**Planning Application by Biffa Waste Services Ltd**

**Application Number: 2011/1088/02**

**Details: Application for an Energy Recovery Facility and ancillary facilities**

# **LANDSCAPE AND VISUAL IMPACT**

**Illustration 1.1**

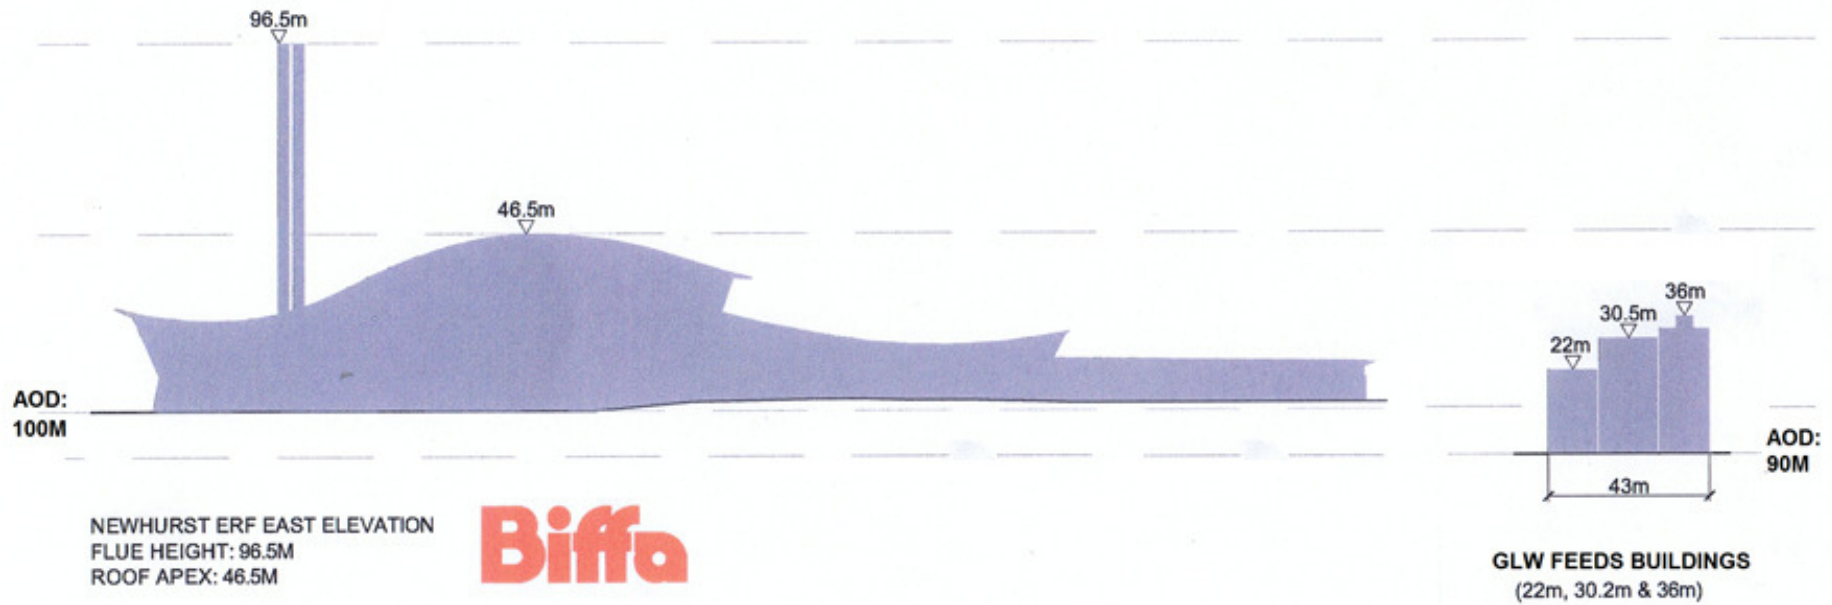
The huge size and height of the facility is clearly shown in Illustration 1.1. This shows the incinerator complex in relation to the GLW Feeds buildings to the north of Ashby Road East, which is already a prominent industrial building in the locality. The incinerator building is 10.5 metres higher than GLW and the flue 60.5 metres higher. In practice, the difference in height is even greater because of an additional 12mAOD between the buildings. That means that the incinerator flue would be no less than 72.5m higher than the GLW building.

The main building mass, flue stacks and plume have more than the **potential** to be visible. They **will** be highly visible from many points in Charnwood Forest, the National Forest and Garendon Park and Estate. Whatever ‘high design standards’ are used, the development will remain a huge industrial building totally at odds with the surrounding countryside. The buildings will also quickly deteriorate. Emissions from the flue stack will be 24/7 and every day hundreds of HGVs carrying every type of waste will enter the complex as well as toxic waste being exported. There is no way in which Biffa will be

able to maintain the visual standards that might be achieved initially. A coat of paint every few years will not solve the problem.

***Illustration 1.4***

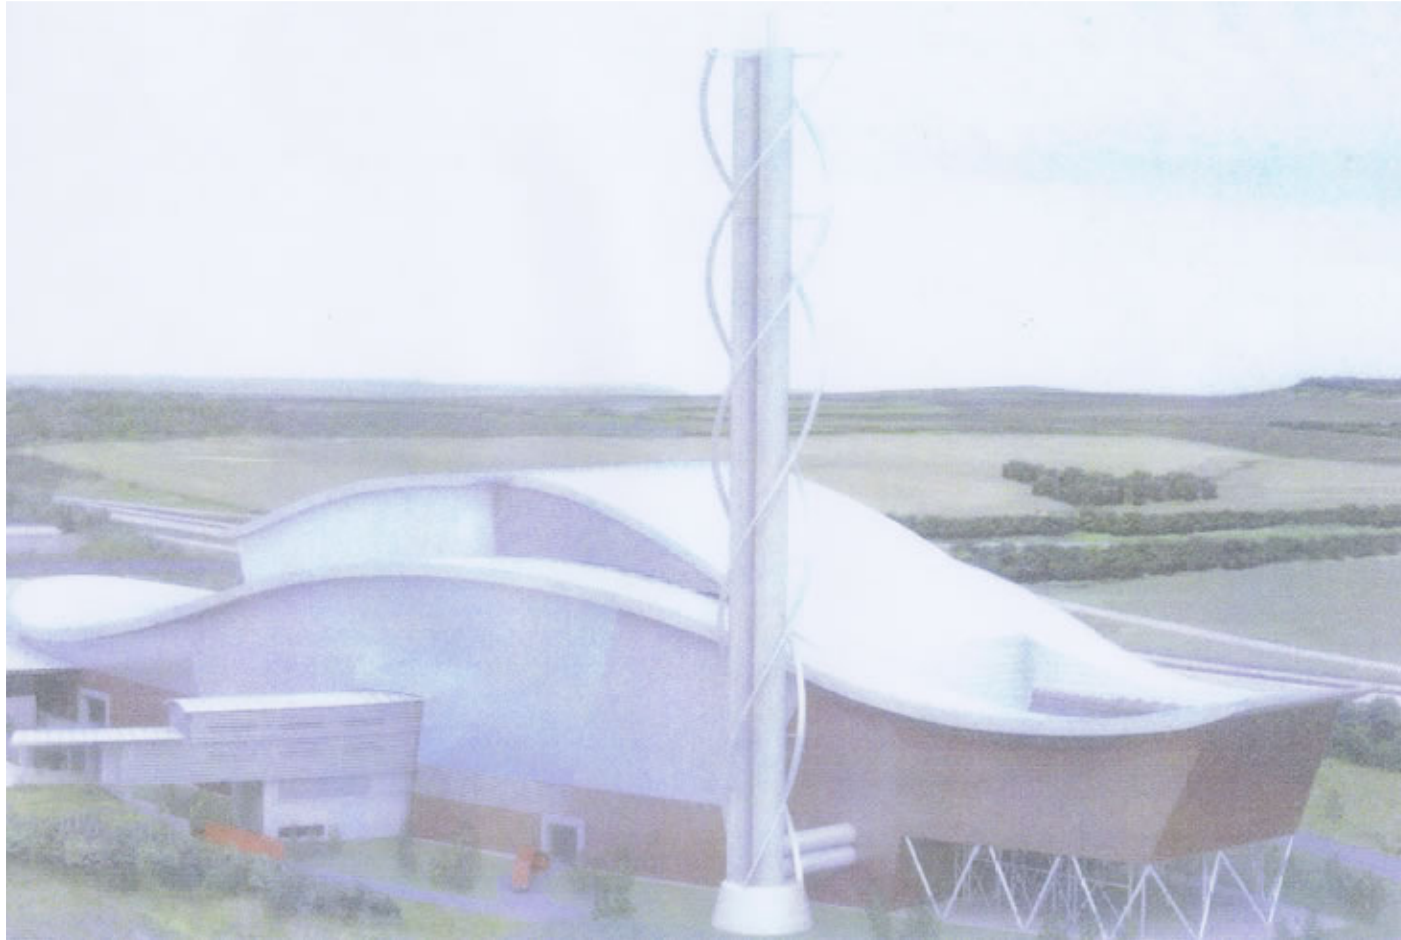
A comparison between the Angel of the North and the Newhurst Quarry Incinerator is shown in Illustration 1.4. At 96.5m the flue stack is almost 5 times higher than the Angel. Even the building mass is some 3 times higher. Instead of the work of art that is the Angel of the North we will have ugly industrial buildings and a smoke plume to greet visitors to our area. Perhaps it would become known as the Demon of the East Midlands!

***Illustration 1.5***

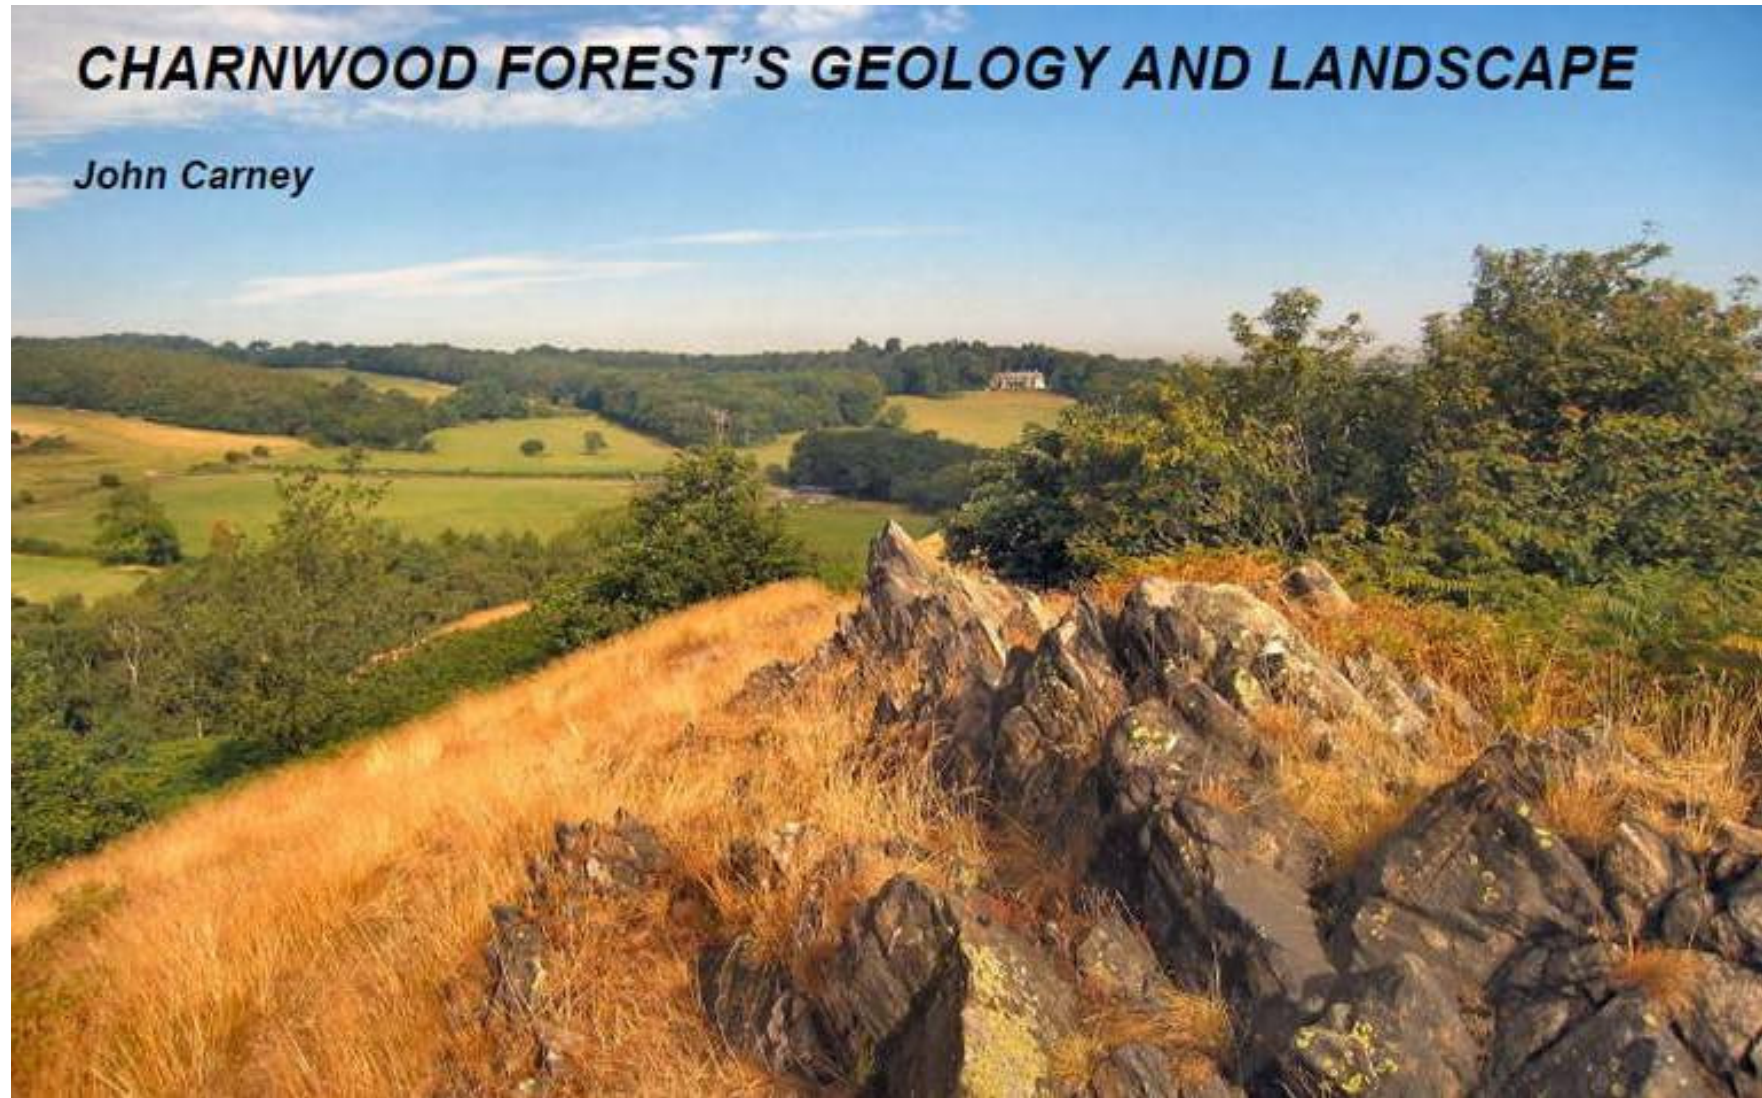
This view is much more relevant though it does not include a montage of the incinerator complex. Residential properties can be seen to the right of the view. Such properties are, perhaps, 10m high compared with the incinerator flue at 96.5M and the main building at 46.5m. This gives some idea of how prominent the incinerator complex would be and how it would spoil the view in an Area of Outstanding Natural Beauty (listed as such in the 'Pictures of England.com' Leicestershire website).

Viewpoint 6 – M1 Junction 23 Bridge

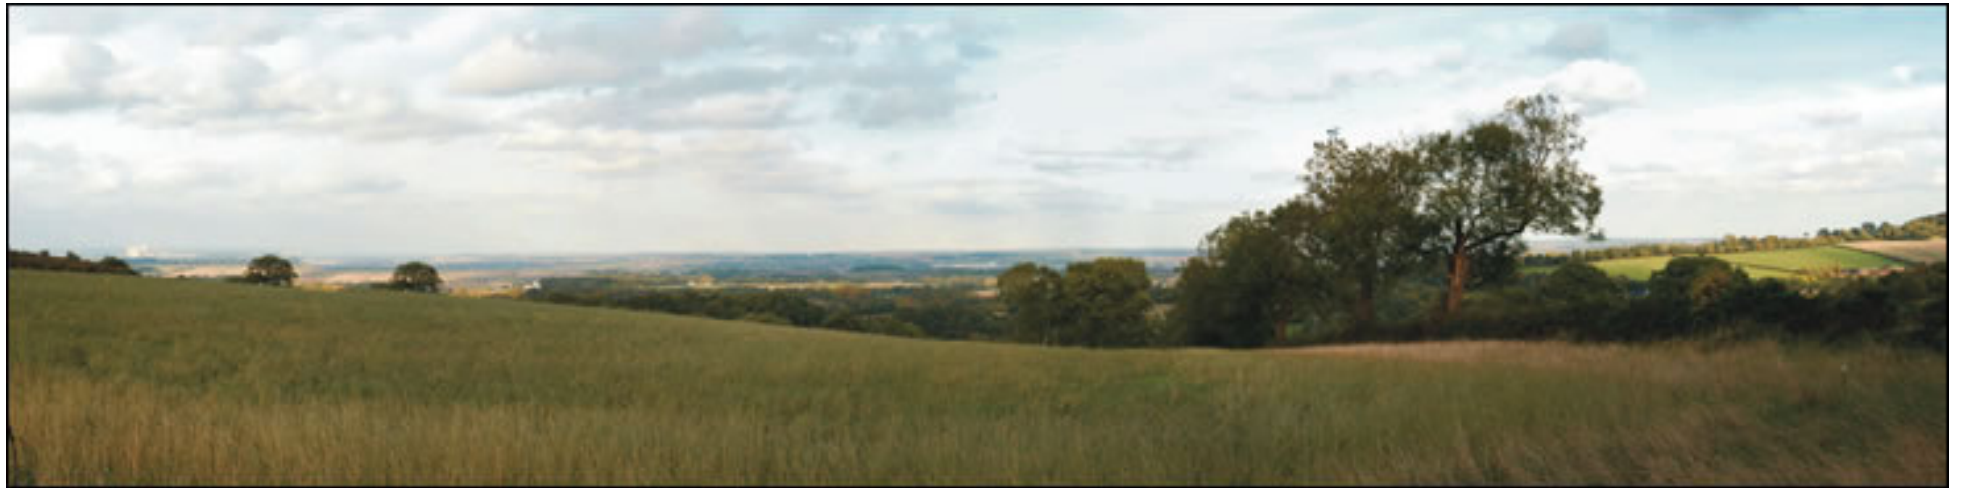
The photomontage version of this view is the only one that gives a realistic impression of the size of the incinerator complex and the huge visual impact it will have and we doubt that even this montage represents the full size, height and elevation. Most visitors to Loughborough/Shepshed come via the M1, exiting at J23. Their first impression will be of a huge industrial building with a smoke plume rising from a very high flue stack.
